Subject: MHI's Response to US-APWR DCD RAI No. 112-785 Revision 0

Response to Request for Additional Information
No. 112-785 Revision 0

US-APWR Design Certification

RAI NO.: NO. 112-785 REVISION 0
SRP SECTION: 06.02.01.04 – Mass and Energy Release Analysis for Postulated Secondary System Pipe Ruptures
APPLICATION SECTION: 6.2.1.4
DATE OF RAI ISSUE: 12/03/2008

Figure 06.02.01.04-1.1 Break Flow from the Intact Steam Generators (downstream of the break)

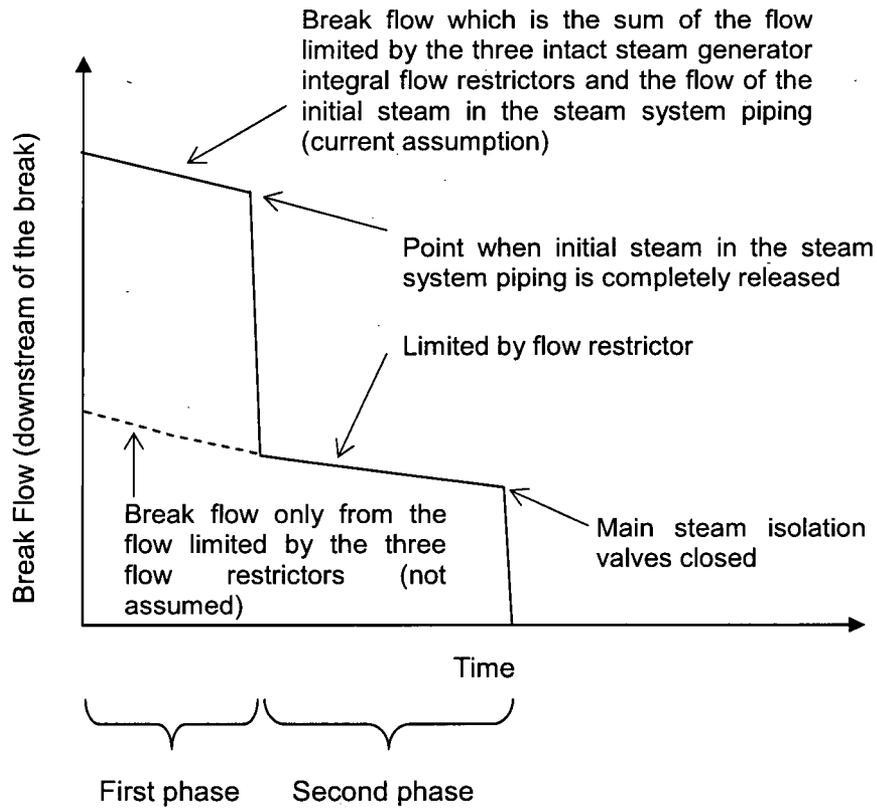
6.2.1.4: In Tables 6.2.1-26 and 6.2.1-27, describing mass and energy release for secondary system pipe ruptures worst accidents, the break flow decreases by a factor of 0.4 at 4.2 s. No explanation of such an event at that event [*sic - this should be time*] is given in Tables 6.2.1-15 and 6.2.1-16. Please, explain.

In DCD Tables 6.2.1-26 and 6.2.1-27, there is a large decrease in break flow that occurs in the time step from 4.0 to 4.2 seconds. For both tables, this decrease in break flow occurs only in the reverse break flow that is downstream of the break (from the intact steam generators). As described in DCD Section 6.2.1.4, the analysis assumes that the intact steam generators blow down through the break until the main steam isolation valves (MSIVs) are closed. As indicated in Table 6.2.1-15 and 6.2.1-16, the MSIVs are assumed to close at 10.0 and 11.0 seconds, respectively. This is also confirmed in Tables 6.2.1-26 and 6.2.1-27 when the break flow from the intact steam generators decreases to zero at the respective times of 10.0 and 11.0 seconds.

As indicated in Figure 06.02.01.04-1.1, there are two distinct phases of the reverse flow from the intact steam generators prior to steam line isolation. The first phase considers the downstream break flow from the steam already in the steam system piping. The break area of the affected steam line shared by the intact steam generators is greater than the sum of the flow area of the three intact steam generator integral flow restrictors. The duration of this phase of break flow is determined by the steam line area at the break, the total volume of the steam lines, and the initial steam line pressure. For the US-APWR, this initial steam release in the steam system piping is calculated to last 4 seconds. In addition, MHI assumes the additional flow that is limited by the three intact steam generator integral flow restrictors. Therefore, the downstream break flow in the first phase is the sum of the flow limited by the three intact steam generator integral flow restrictors and the flow of the initial steam in the

steam system piping. The second phase is that the 1.4 ft² integral flow restrictors will limit the flow from each intact steam generator. The reduction of flow by a factor of approximately 0.4 between 4.0 and 4.2 seconds is caused by the transition to flow only controlled by the flow restrictors after the complete release of the initial steam in the steam system line.
